Subject: FW: 110412 FAI 037 Safety Project D5 Requests Cost Proposal ASAP

Subject: RE: FAI-37-6.34 Preliminary Right of Way Plans (PID No. 110412)

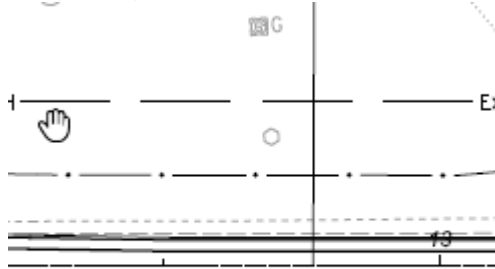
- Missing sheet 20 of 37 as Luke stated.
- Page 21/36 (22/37) Parcel 11-SH shows "Utility Pole Save" for private light poles. I would have them removed as ODOT will need to pay for them anyways (in take area) and would need to do a permit (not recommended) for the poles that are very close to the fence needing removed. Same Parcel has three of those poles (not 2) and also has a small sign near the fence that was not picked up on these plans:
